# EGGS-TRAORDINARY SITE AND DEVELOPMENT PLAN

18-15SP

**REQUEST:** To approve architectural design for façade improvements to an existing building to confirm compliance with the Venetian Urban Design (VUD) overlay district standards.

*FIGURE 1: Existing Southern and Eastern Building Elevations*

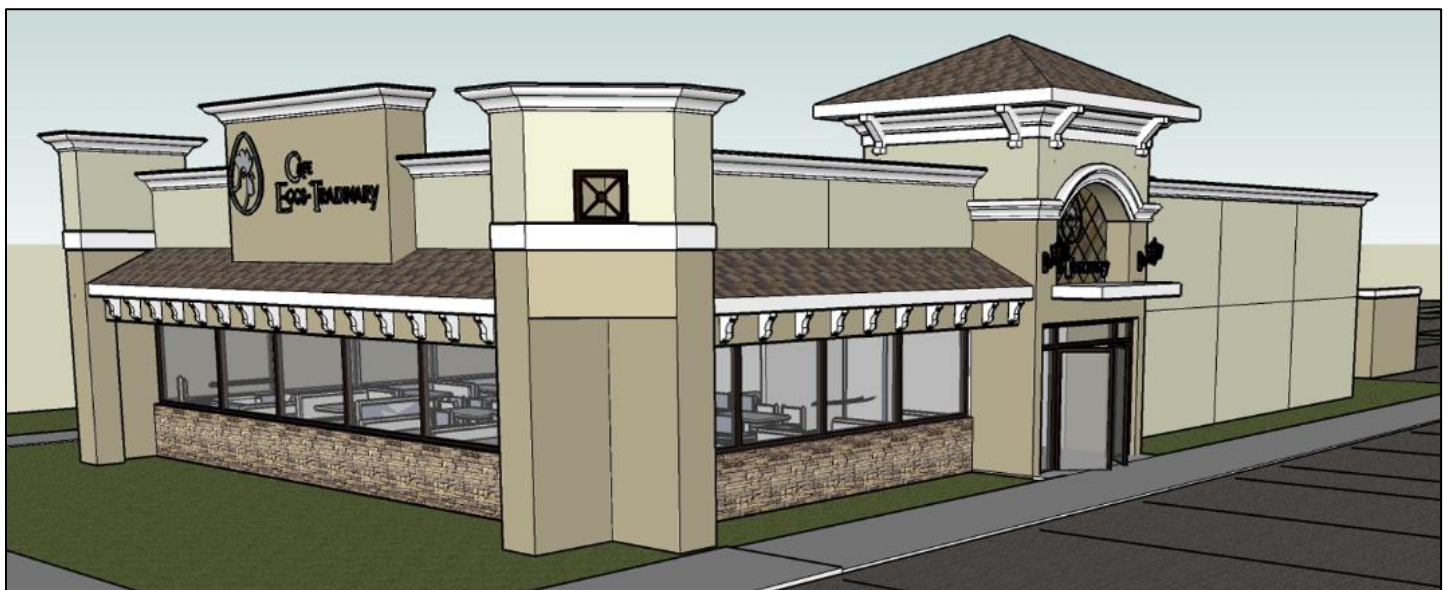
Figures 1 and 3 on Page 3 and 4 show the existing structure built in the 1980s, prior to the addition of the VUD overlay standards. The existing structure includes a mansard-style roof with green barrel-tile, white stucco walls, and terracotta-colored accents walls. The VUD overlay district requires the Northern Italian Renaissance style of architecture.
